DEPARTMENT OF TRANSPORTATION

Contract #: 04-0120F4Cty: SF/ALA Rte: 80 PM: 13.2/13.9File #: 69.28**WELDING INSPECTION REPORT****Resident Engineer:** Siegenthaler, Peter**Address:** 333 Burma Road**City:** Oakland, CA 94607**Report No:** WIR-019205**Date Inspected:** 03-Dec-2010**Project Name:** SAS Superstructure**OSM Arrival Time:** 700**Prime Contractor:** American Bridge/Fluor Enterprises, a JV**OSM Departure Time:** 1900**Contractor:** Zhenhua Port Machinery Company, Ltd (ZPMC), Changxing Island **Location:** Shanghai, China

This QA inspector performed VT of the bike path component internal area previously tested by ZPMC Quality Control personnel. The part is internal components, before welding of closure plates. The member is identified as OBG Components. The bike path designations reviewed are as follows:

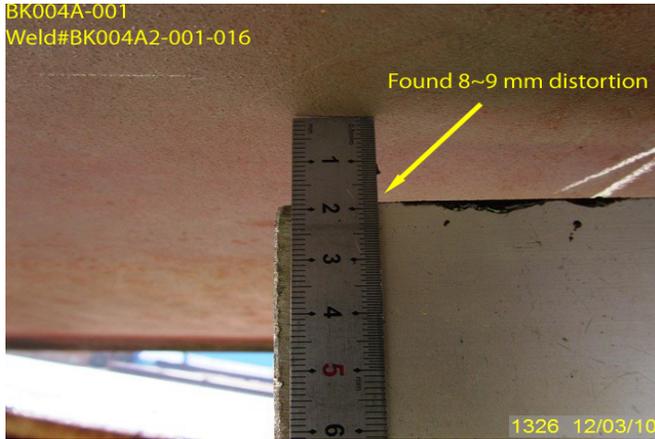
-During random DCP check, this QA inspector observed out of flatness across the weld exceed the allowable tolerance.

-The component is Bike Path bottom cover plate, seam weld.

-The thickness of the bottom plate is 6mm.

-According to the Standard Specification 1999, Section 55, flatness of the splice weld is measured by 600mm straight edge and the allowable tolerance is 5mm.

-Maximum out of flatness was observed as 7 mm on bike path BK004A-001, weld#BK004A2-001-016,
9.5mm on bike path BK004A-003, weld#BK004A2-003-016.
7.5mm on bike path BK004A-003, weld#BK004A2-008-016-full length.
7.5mm on bike path BK004A-003, weld#BK004A2-008-018.
10mm on bike path BK004A-003, weld#BK004A2-010-018.
